TM 11-6625-496-45

TEST SET, RADIO AN/VRM-l

Change
No. 6

General Support and Depot Maintenance Manual Including Repair Parts and Special Tools Lists TEST SETS, RADIO AN/VRM-1 AND AN/VRM-1A (NSN 6625-00-892-5542)

Figure 39.1. TS-1777A/VRM-1 and later production units of TS-1777/VRM-1, schematic diagram.

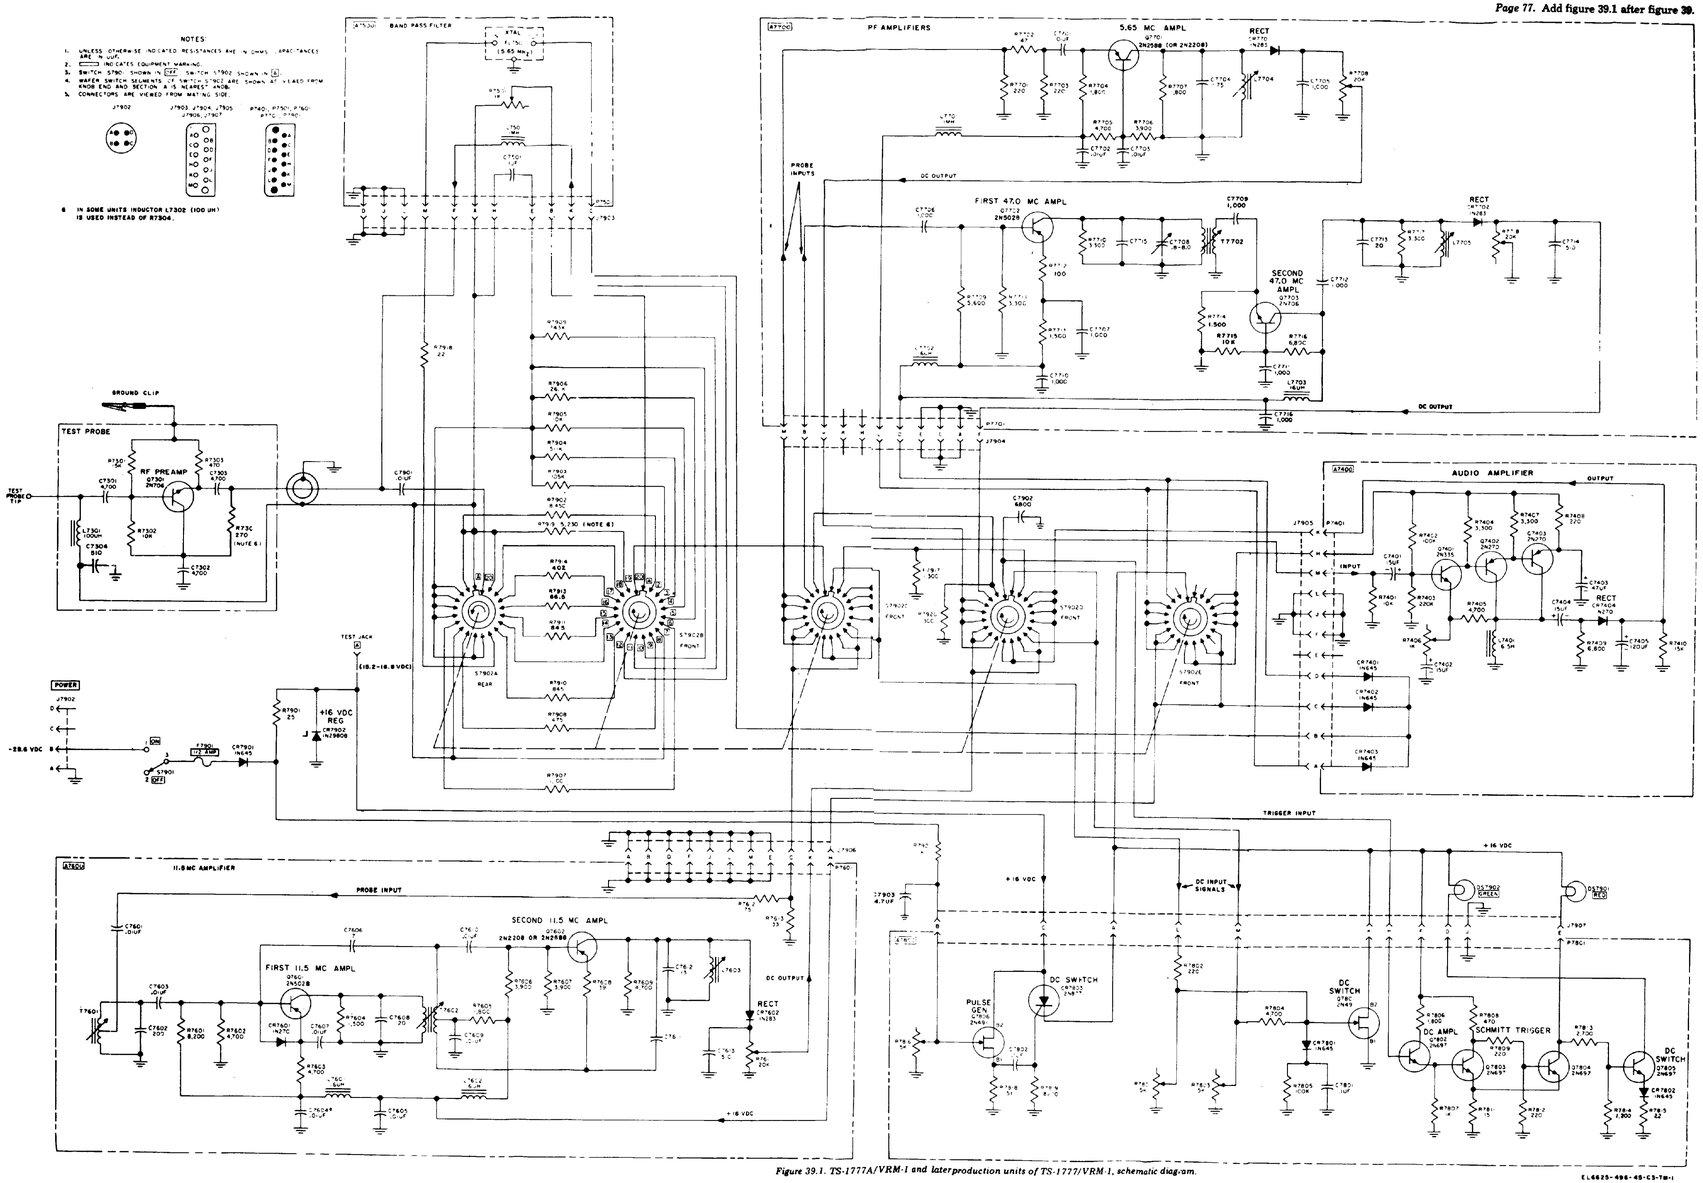
Page 11 of C 4, figure 39.1. Make the following changes:

At C7602, add 220 UUF (NOTE 7).

At Q7602 and Q7701, add OR 2N1225 (NOTE 8).

At Q7402 and Q7403, delete "2N270" and insert the following: 2N270 (MOD) OR 2N599 (NOTE 8).

Figure 39.2. TS-1777A/VRM-1 schematic diagram.

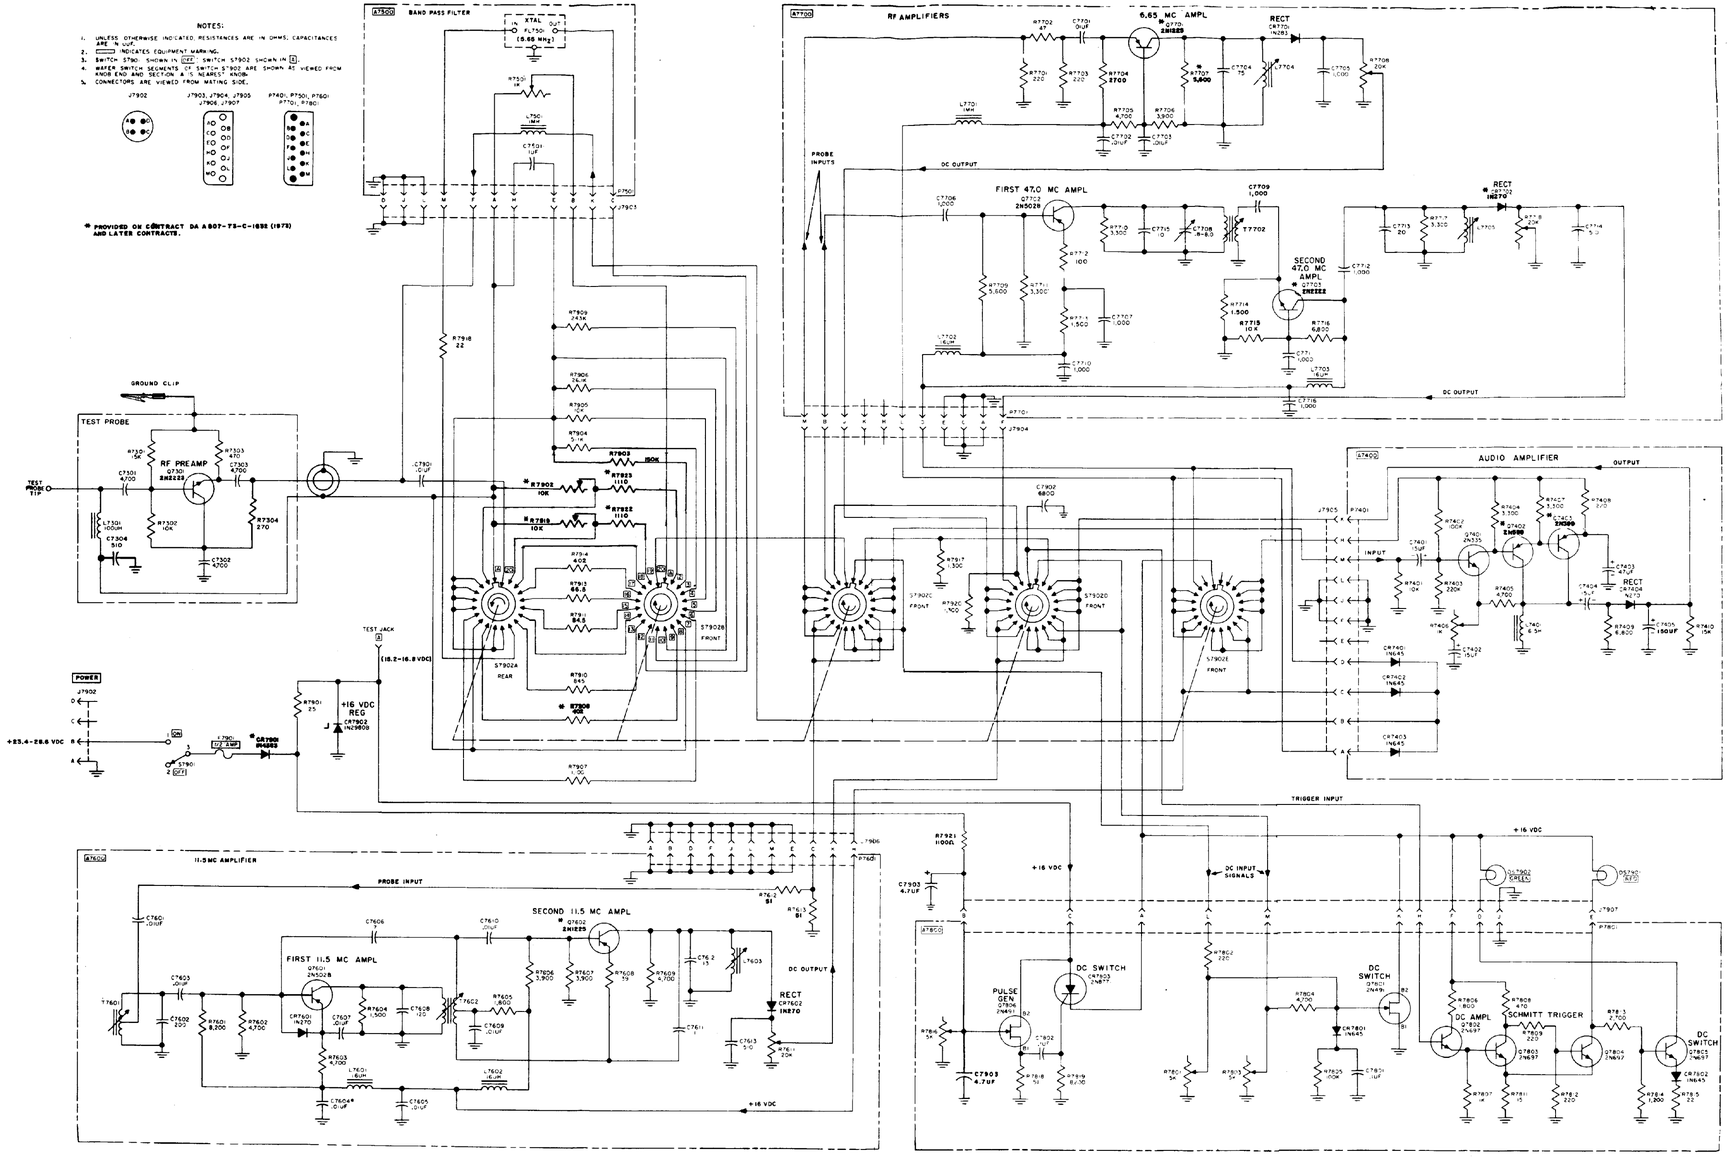
(c) Resistor R790S (figs. 17 and 55) has been changed from 475 ohms (fig. 39.1) to 402 ohms (NSN 5805-00-818-5548) (fig 39.2) This allows the midpoint trigger leve1 for selector switch positions 9 and 14 to be set closer to the median value for triggering. This action provides a more optimized operating point. Switch position 14 must be set near the lower limit to maintain switch position 9 value below the operating limit.

Page 77. Add figure 39.2 after figure 39.1.

Figure 1. Audio amplifier, schematic diagram.

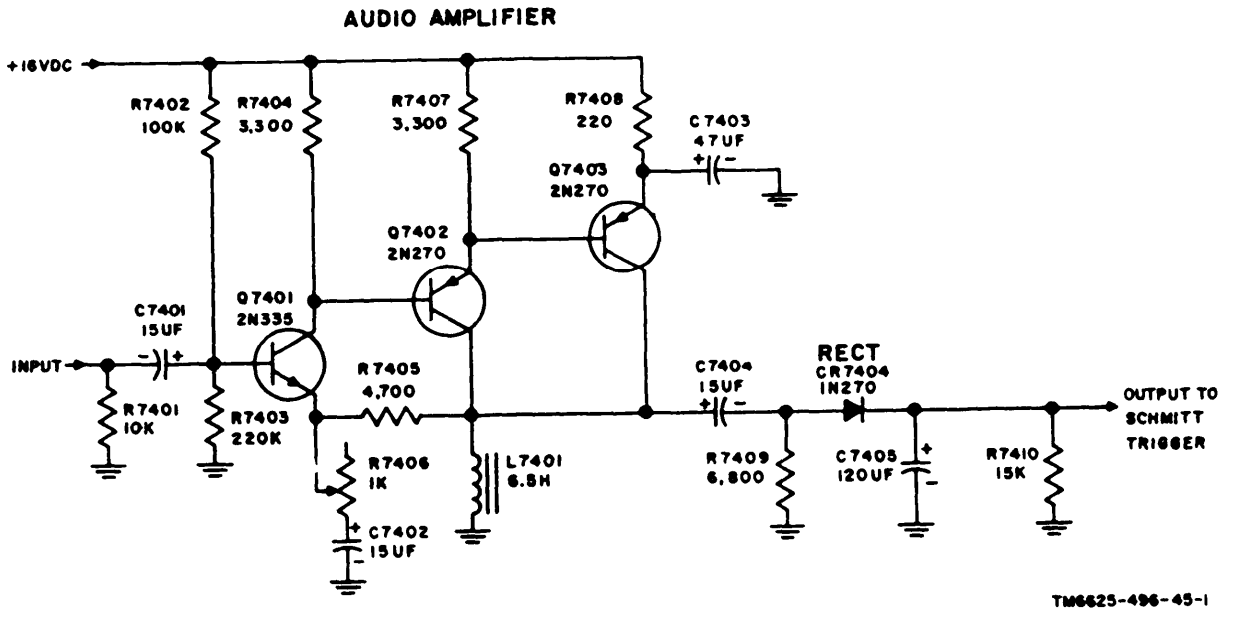
Page 4, figure 1. At Q7402 and Q7403, delete "2N270" and insert "2N270 (MOD) OR 2N599."

Figure 2. Amplifier, 11.6-mc, schematic diagram.

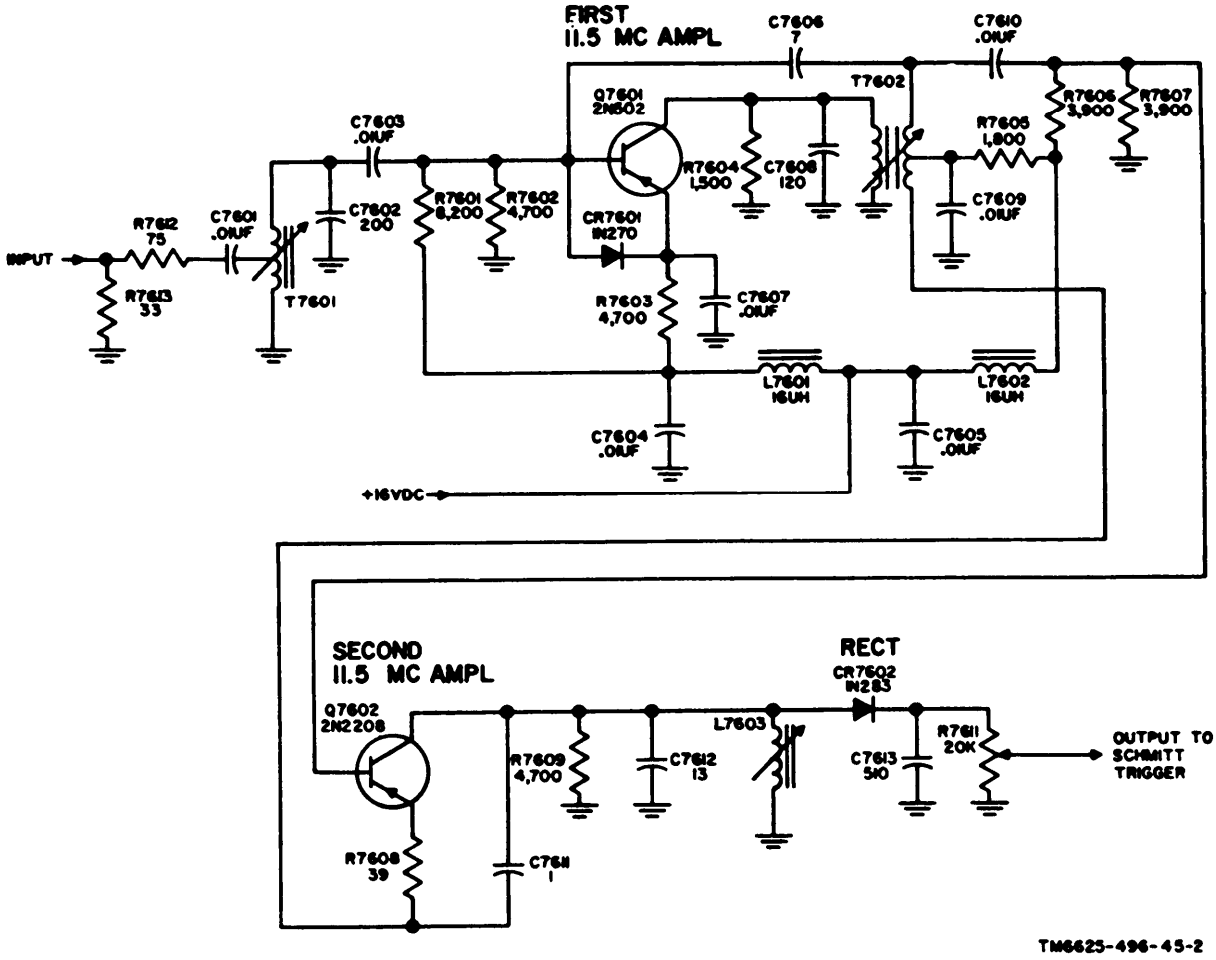
Page 5, figure 2. Make the following changes:

Change the resistance value of “R7612” and “R7613” to: 51 (ohms). Add the following:

Page 5, figure 2, FIRST 11.5 MC AMPL (as changed by C 1, 13 Jan 64). Change transistor Q7601 type from "2N502" to: 2N502B.

Figure 3. Amplifier, 5.65-mc, schematic diagram.

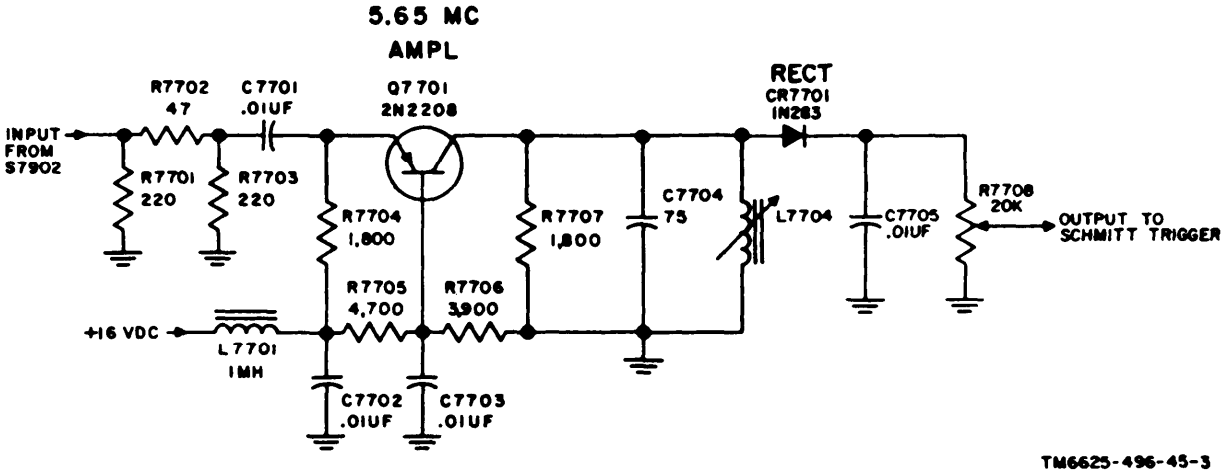
Page 6, figure *3.* To *"2N2208"* at Q7701, add 2N588 OR $2N1225_0$

Page 6, figure 3 (as changed by C 1, 13 Jan 64). Change the value of R7707 from " 1800" to: 5.6K.

Figure 4. Amplifier, 47.0-mc, schematic diagram.

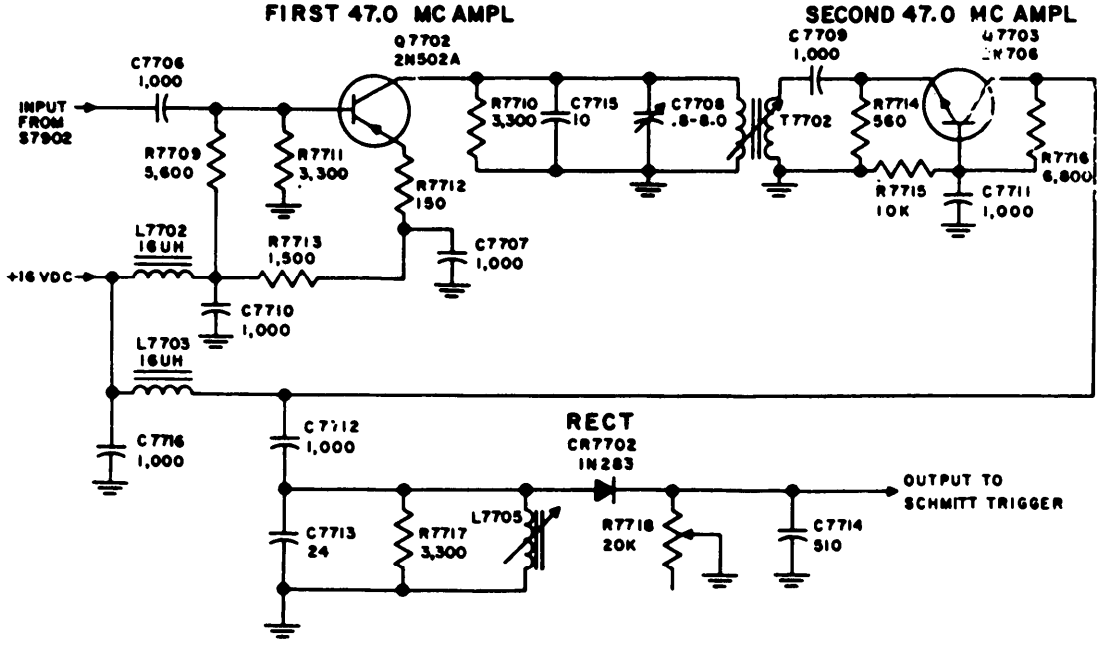
Figure 4, FIRST 47.0 MC AMPL (as changed by C 1, 13 Jan 64). Change the transistor Q7702 type from "2N502A" to: 2N502B.

Figure 14. Test Set, Radio TS-1777/VRM-1 front panel and chassis, rear view, chassis bottom plate removed.

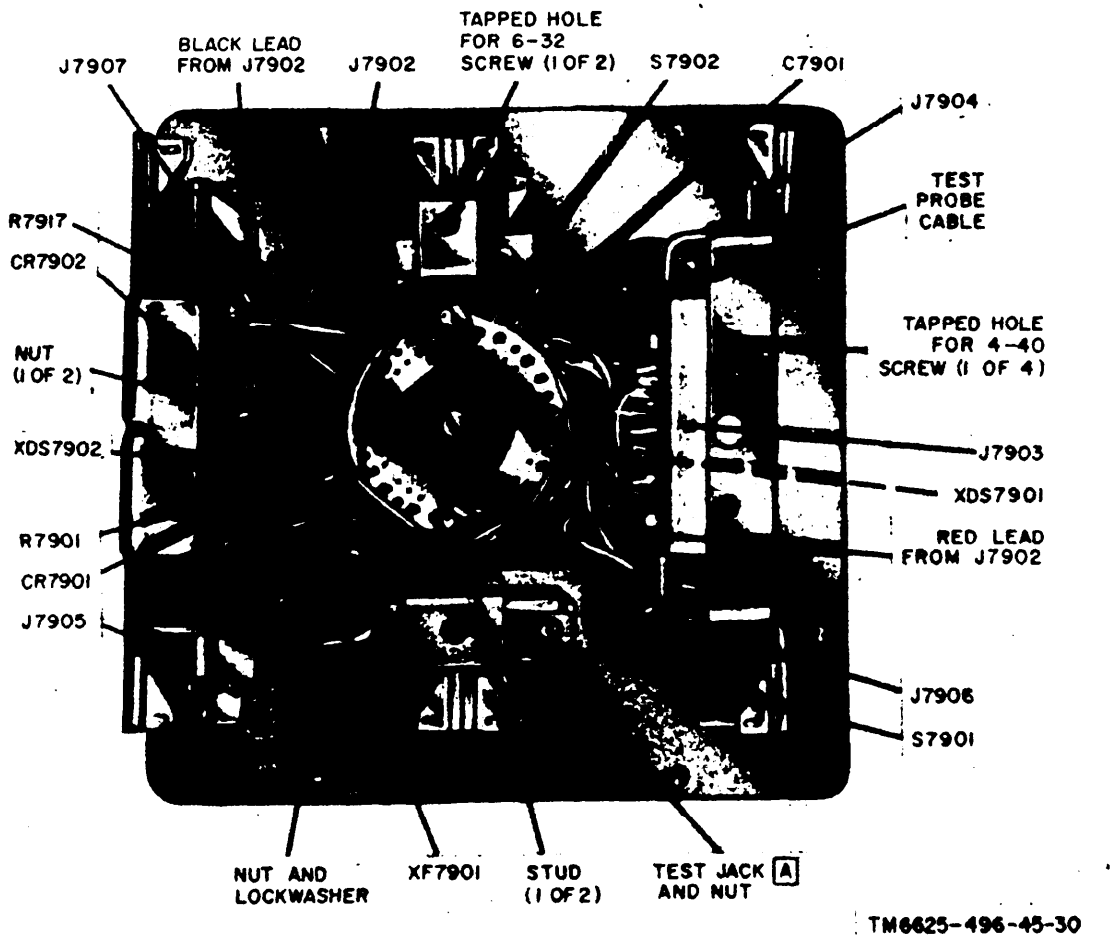
(a) The thermal resistance of diode CR7902 and resistor R7901 (figs. 14 and 54) is reduced by the application of a silicon heat sink compound (Dow Corning No. 340) between the mating surfaces.

(b) Diode CR7901 (figs. 14 and 54), type 1N645, is rated at 400 milliamperes (ma) maximum current. Actual current measurements arc in excess of 400 ma when tested at 28.6 volts dc. Therefore, CR7901 is now type 1N4383 (NSN 5961-00-765-6578) which is a l-ampere device. This will result in a reduced statbilization period.

Figure 39. Test Set Radio TS-1777/VRM-1, schematic diagram.

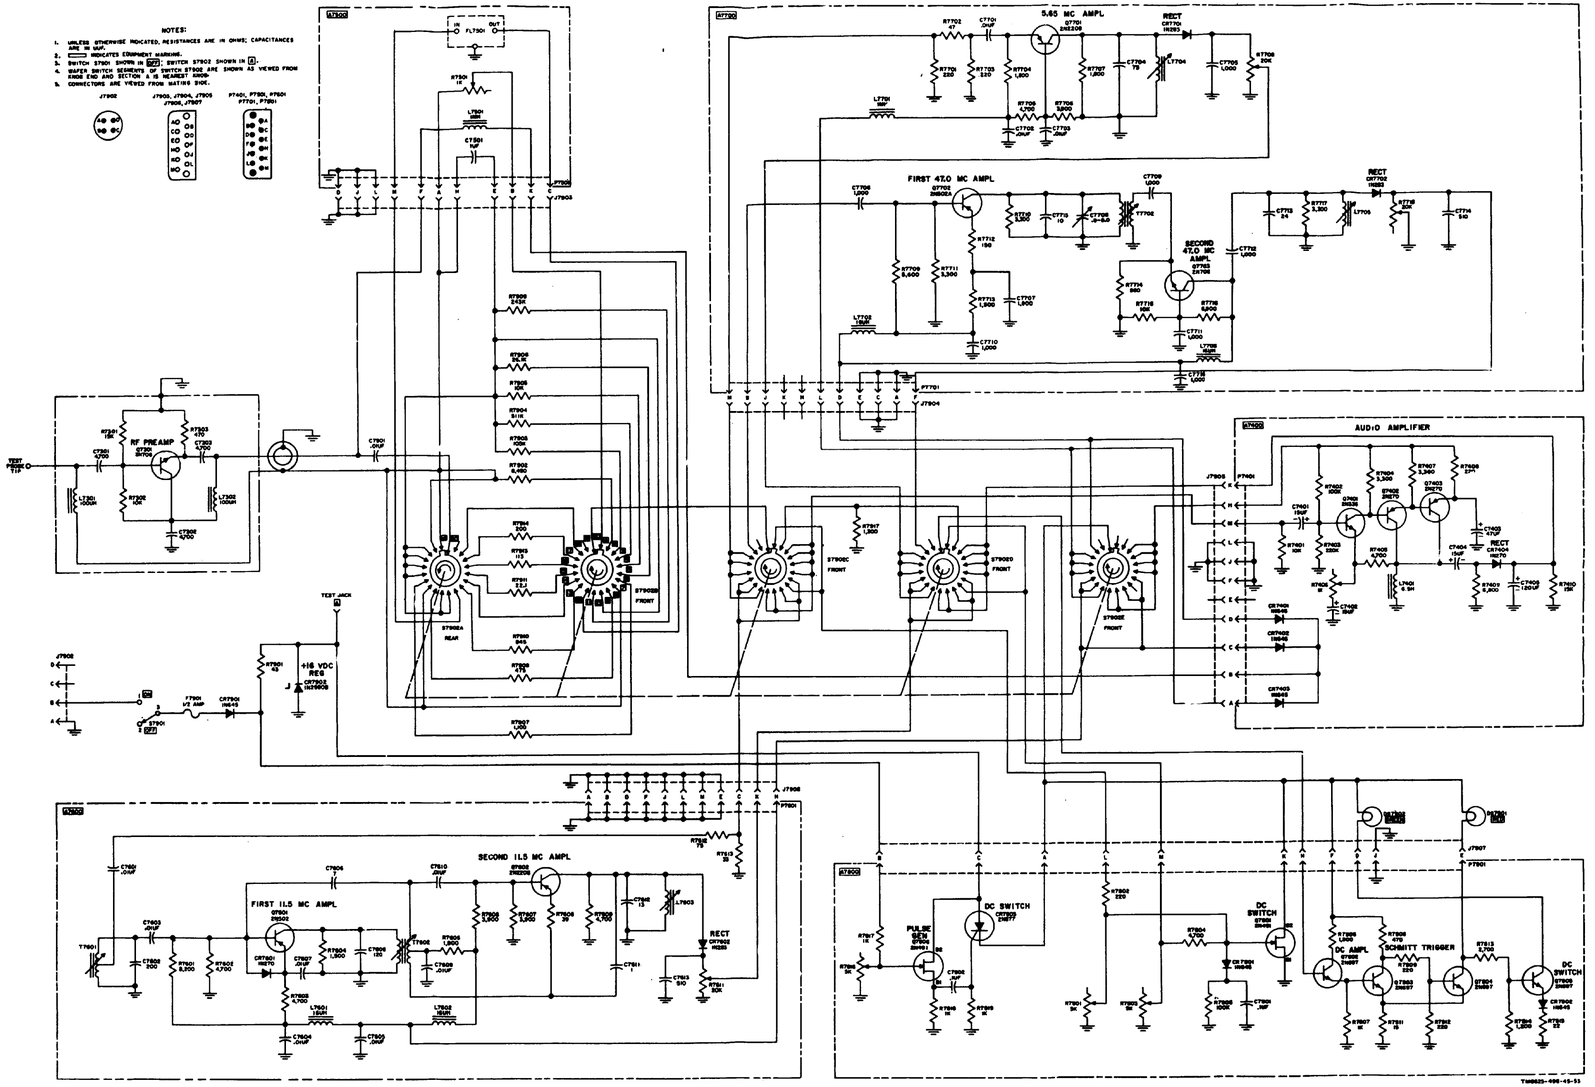
Page 77, figure 39 (as changed by C 1, 13 January 1964). Make the following changes:

R7911. From "22.1" to: 84.5.
